STAFF REPORT

SHORELINE SUBSTANTIAL DEVELOPMENT PERMIT

Project No.:	SHL22-021
Description:	Shoreline Substantial Development Permit to expand an existing residential pier and permit two existing boat lifts.
Applicant / Owner:	Dray Davick (Seaborn Pile Driving) / Jenn Henry
Site Address:	6802 96 th Ave SE, Mercer Island, WA 98040; Identified by King County Assessor tax parcel number 258070-0005.
Zoning District:	Single Family Residential (R-8.4)
Staff Contact:	Andrew Leon, Planner
Exhibits:	<ol style="list-style-type: none">1. Development Application, dated August 12, 20222. Development Plan Set, dated March 1, 20233. Applicant Narrative and Project Narrative, received by the City of Mercer Island on March 3, 20234. Review Response letter, dated March 3, 20235. Ecological No Net Loss Assessment Report, prepared by Northwest Environmental Consulting, LLC, dated March 20236. Geotechnical Report, prepared by The Riley Group, Inc., dated November 22, 20227. U.S. Army Corps of Engineers permit approval (reference number 071-0YB-002164), dated August 13, 19748. SEPA Checklist, dated September 20, 20229. SEPA Mitigated Determination of Nonsignificance Issued by the City of Mercer Island o

SHEET
6.0

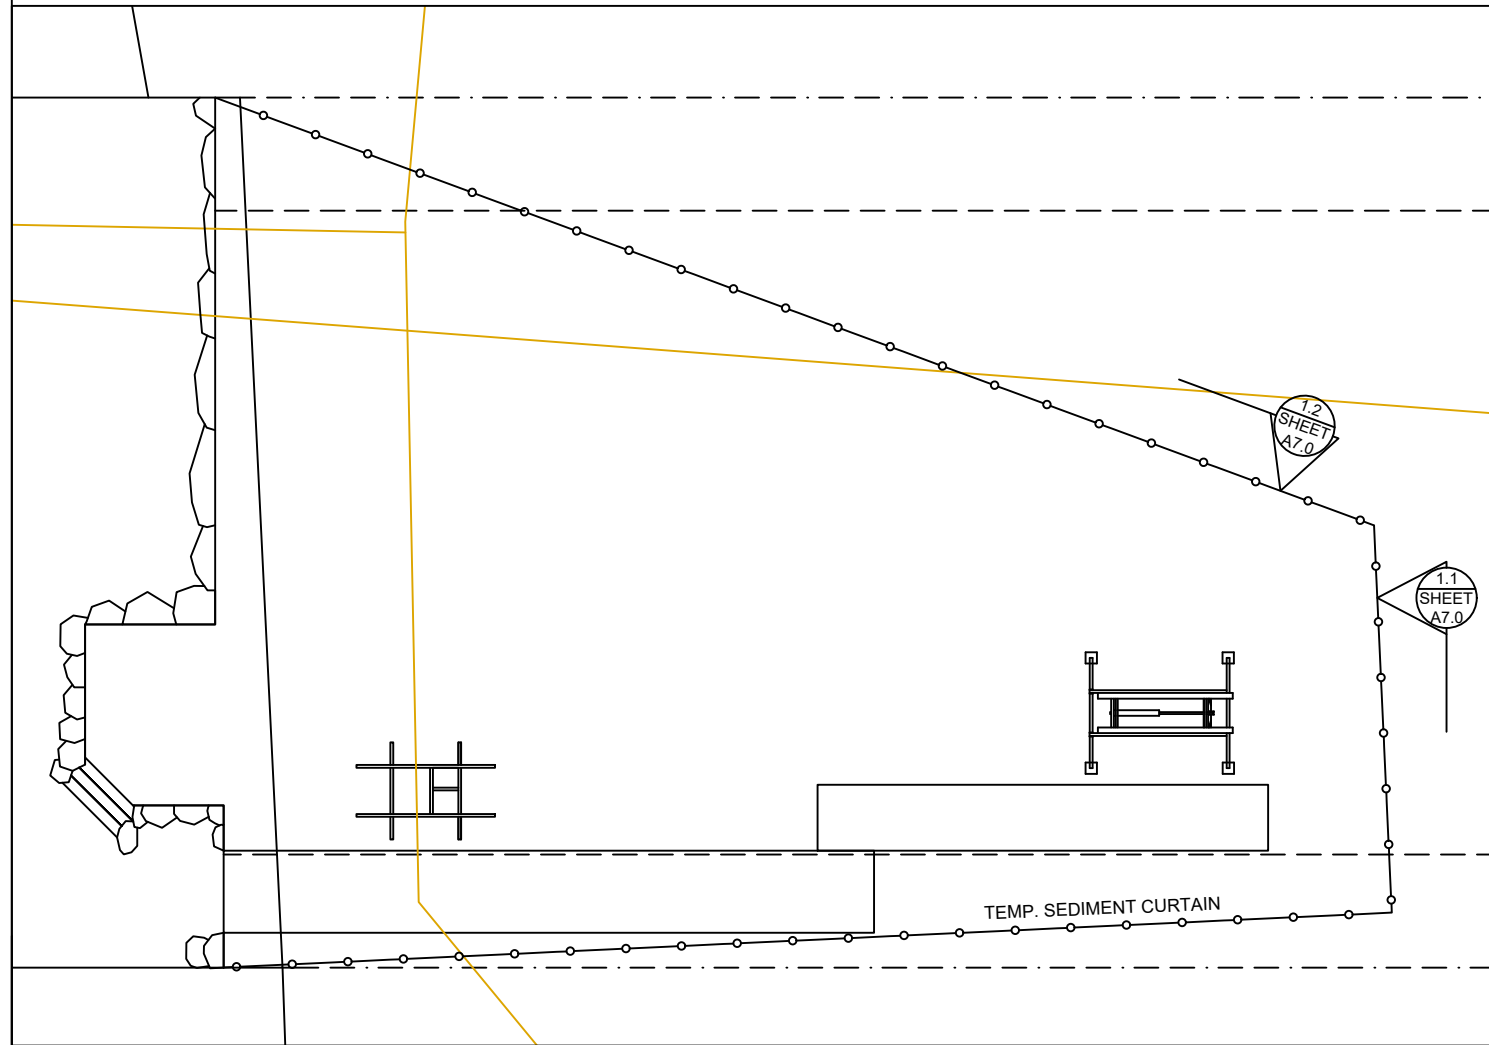
Staff Analysis: The elevation view on Sheet A5.0 of Exhibit 2 shows that the pier does not include walls, rails, or storage containers. This standard is met.

EXISTING HARDSCAPE CALCULATION DRAWING

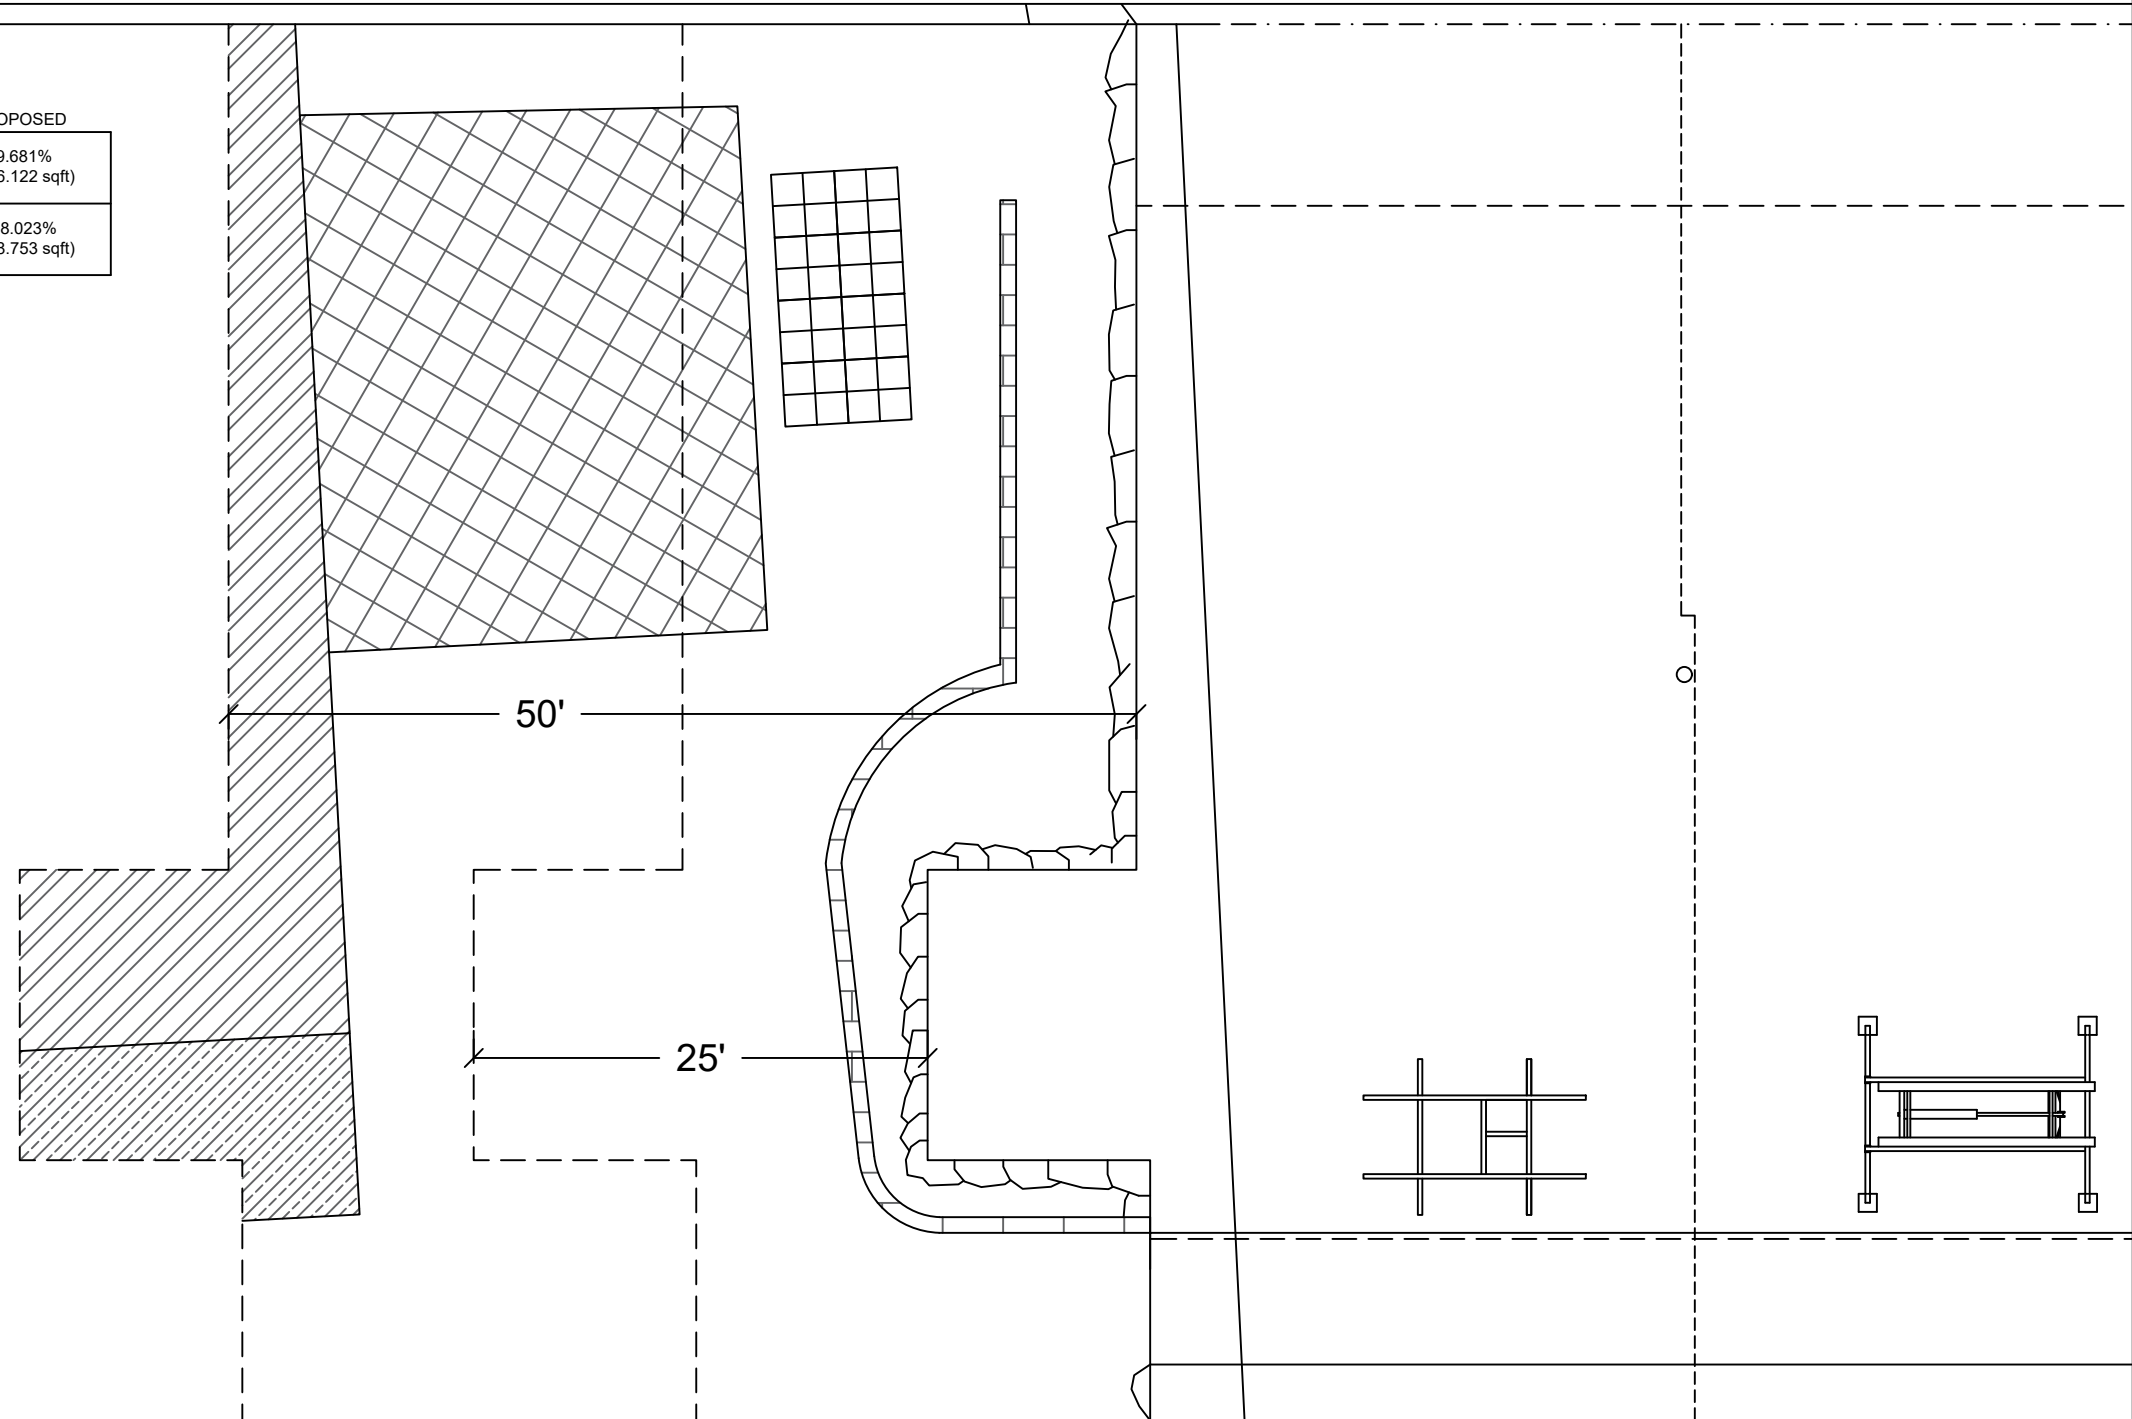
8. Please provide surface coverage (lot coverage and hardscape) calculations showing that the following standards are met:

See sheets A15 & A16 of revised plan set.
